## HISTORIC PRESERVATION COMMISSION

Date: October 31, 2023

SUBJECT: Historic Area Work Permit #1003919 REV: For building addition, parking lot expansion, fence installation, and site improvements.

The Montgomery County Historic Preservation Commission (HPC) has reviewed the attached application for a Historic Area Work Permit (HAWP). This application was **Approved with seven (7) conditions** at the January 11, 2023 HPC meeting.

**SITE PLAN**

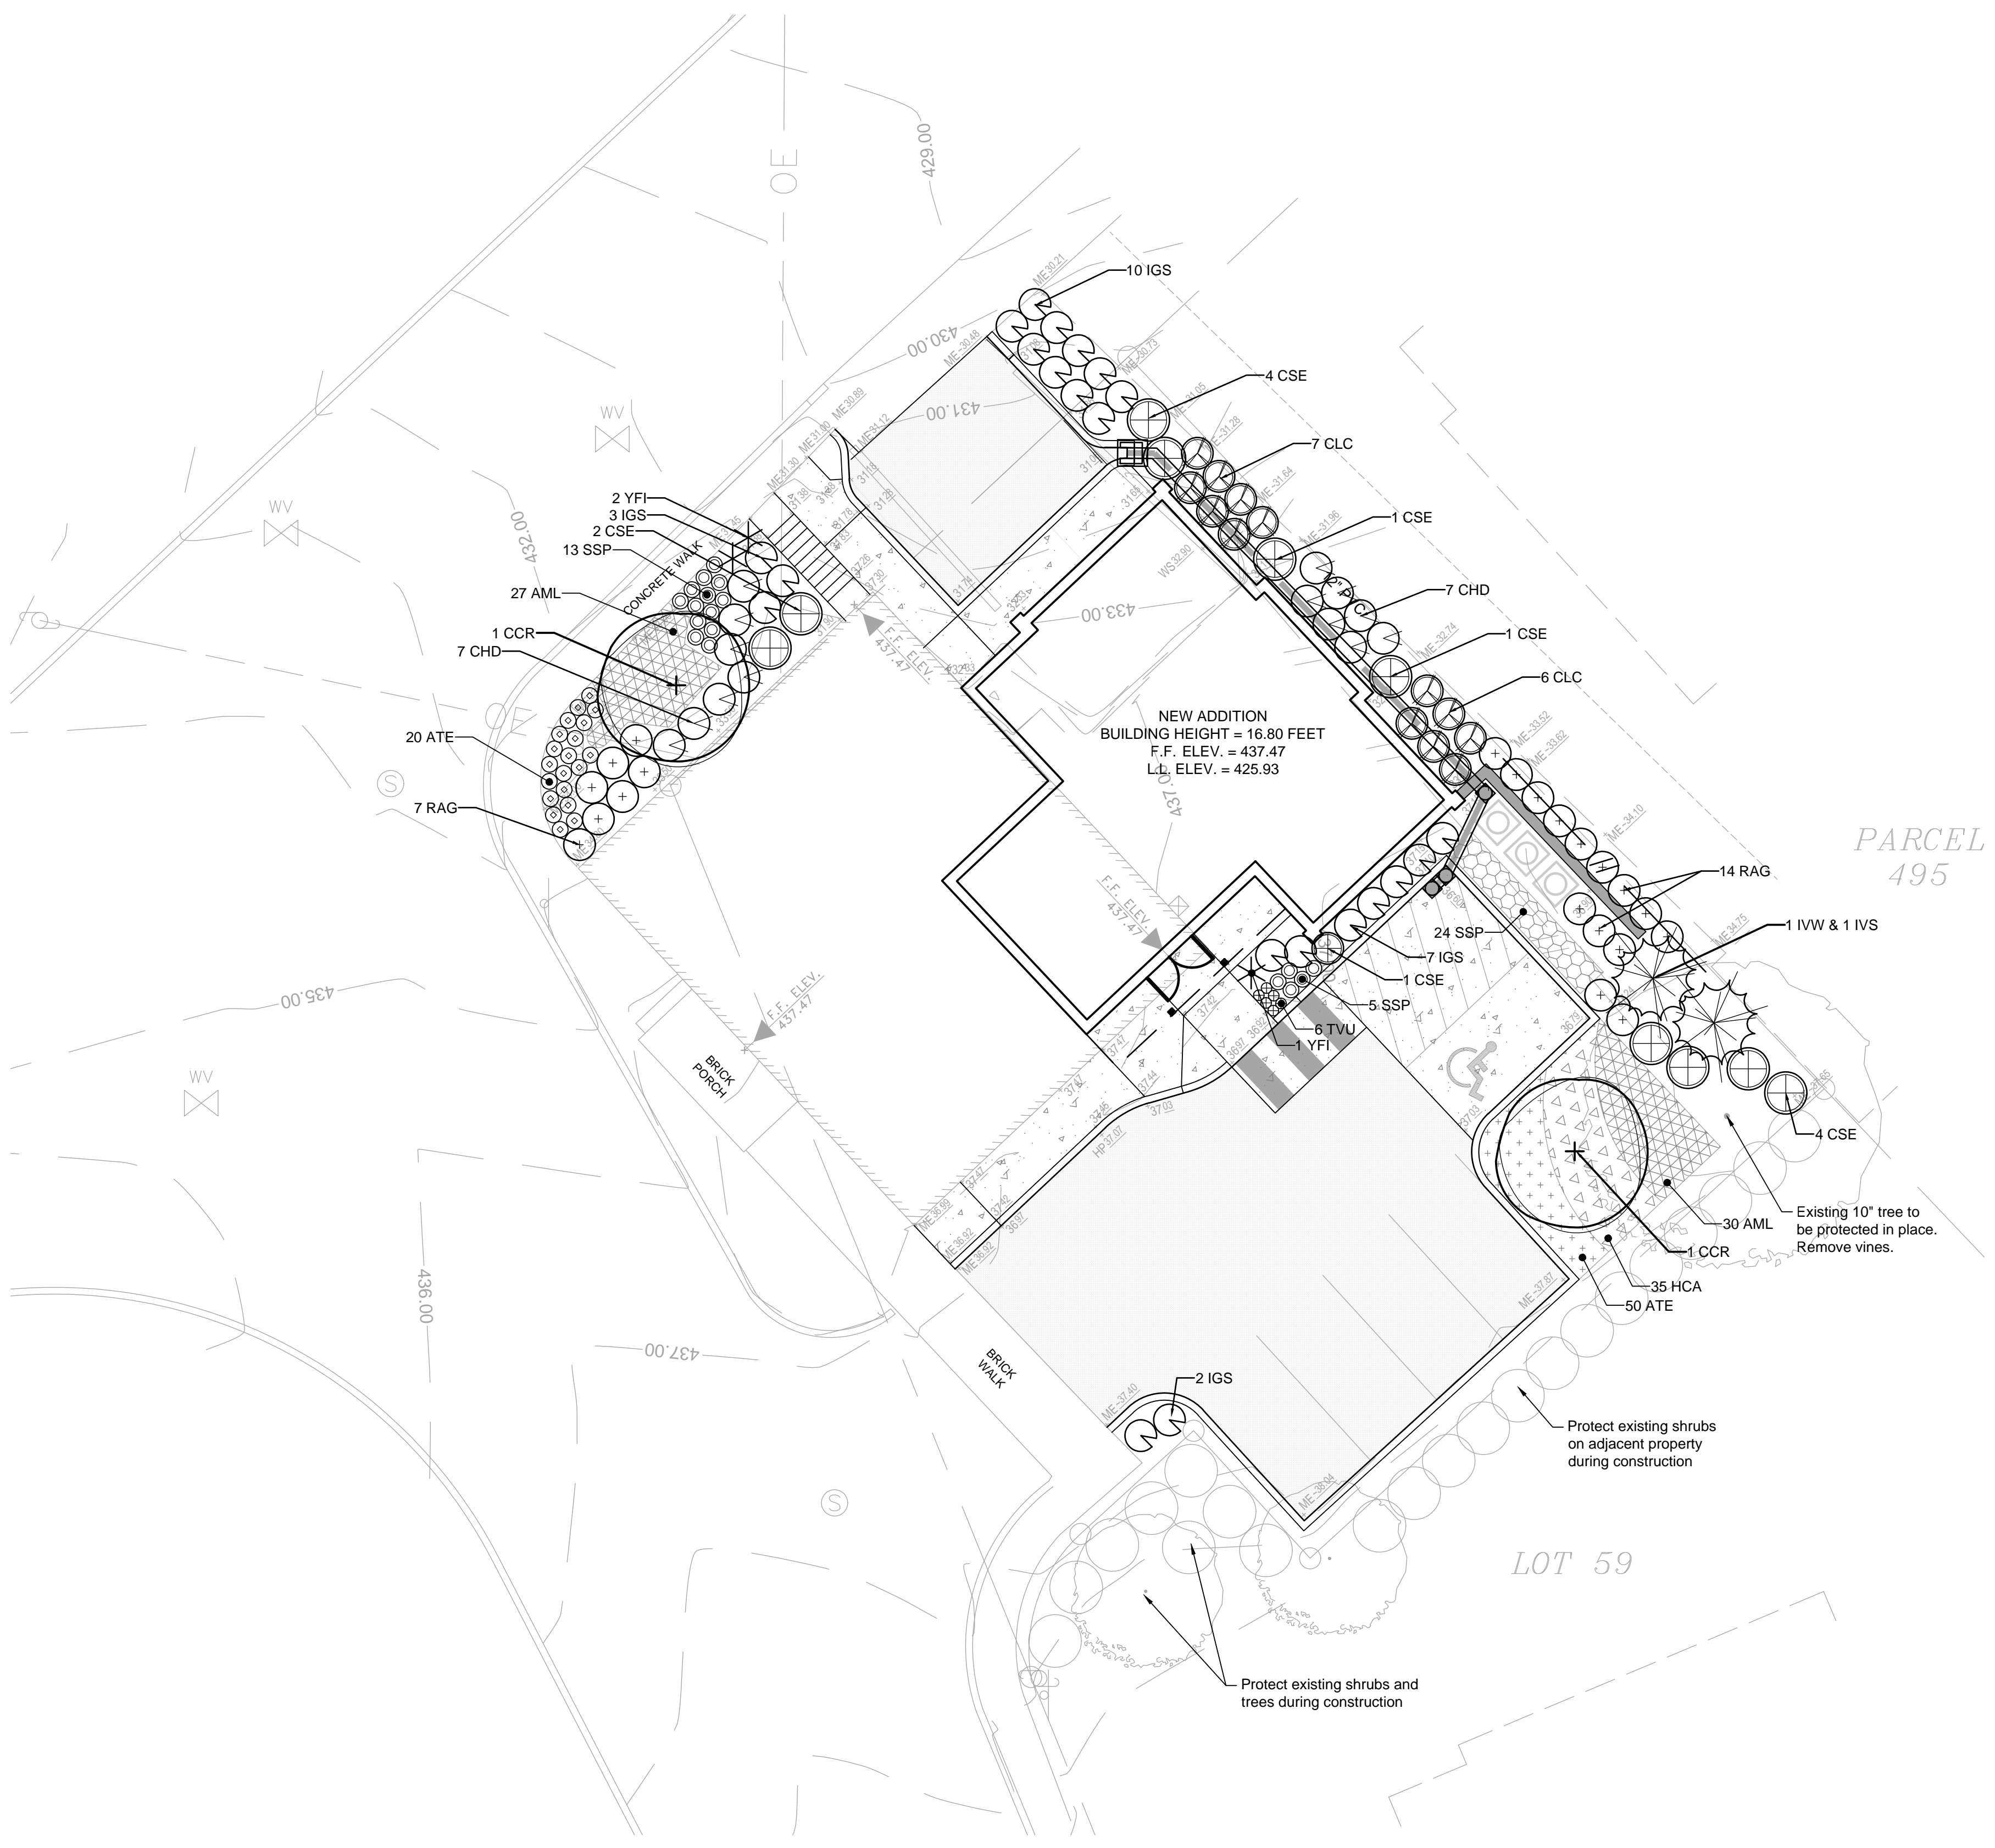
- 6. A revised grading plan showing the removal of the brick retaining wall and the addition of any other retaining walls, if necessary, must be submitted as a revision to this HAWP#1003919 for review and approval by the HPC prior to the issuance of any building permits.**

- 7. A new HAWP for the tree removal must be submitted to the HPC for review and approval, along with a revised planting plan showing the location of newly planted trees, prior to the issuance of any building permits. The new planting plan must be approved by the Town of Brookeville prior to the issuance of any building permits.**

**WINDOW SCHEDULE**

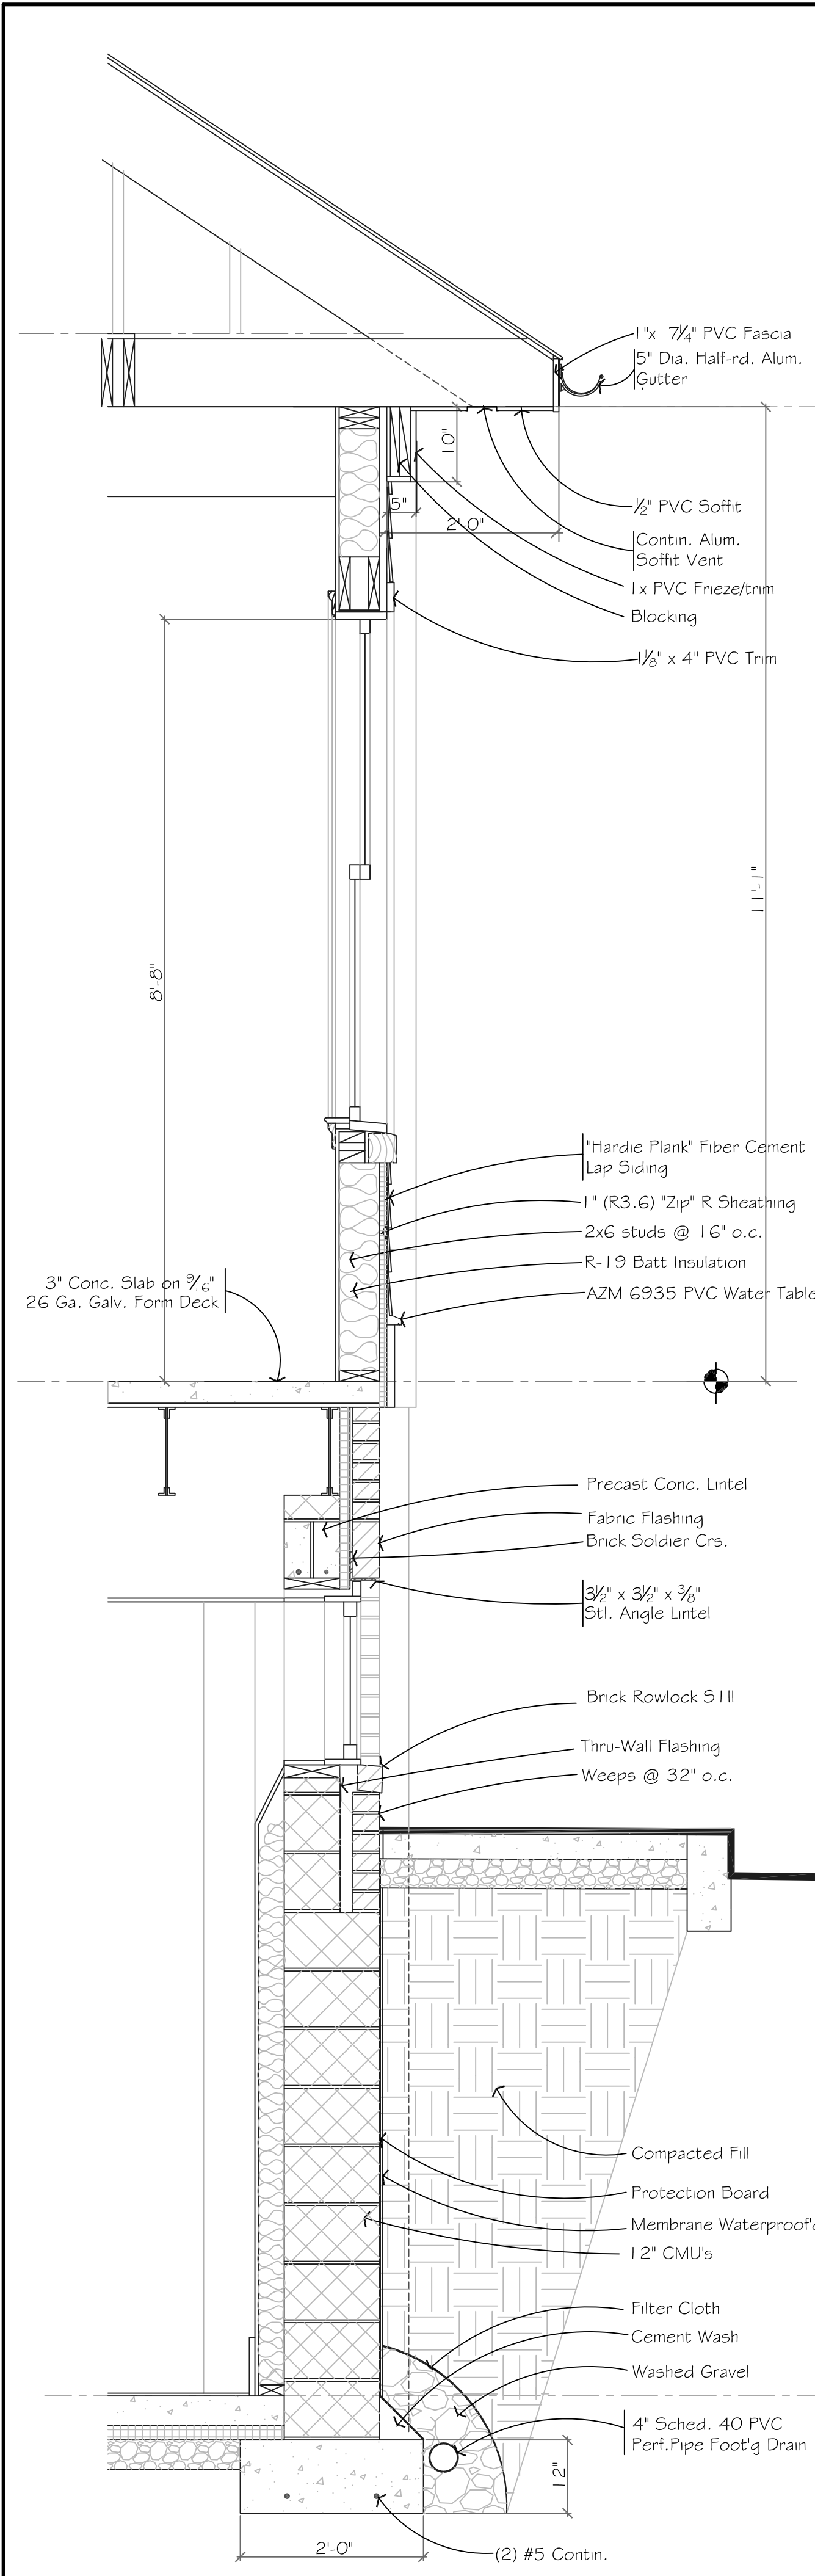
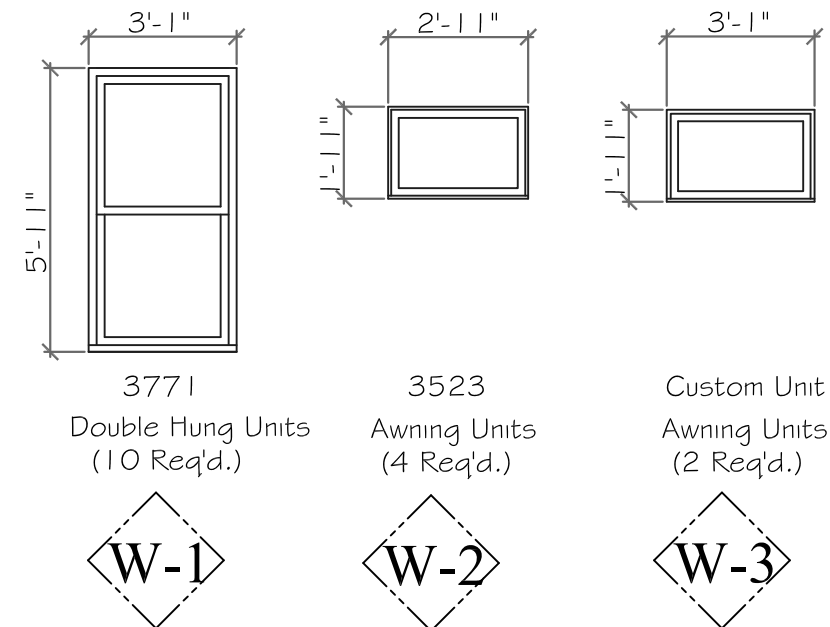
- 5. A complete window and door schedule, including the new dormer windows and basement windows, will be submitted to staff, and final review and approval are delegated to staff prior to the issuance of the building permit. These windows will be aluminum clad wood.**
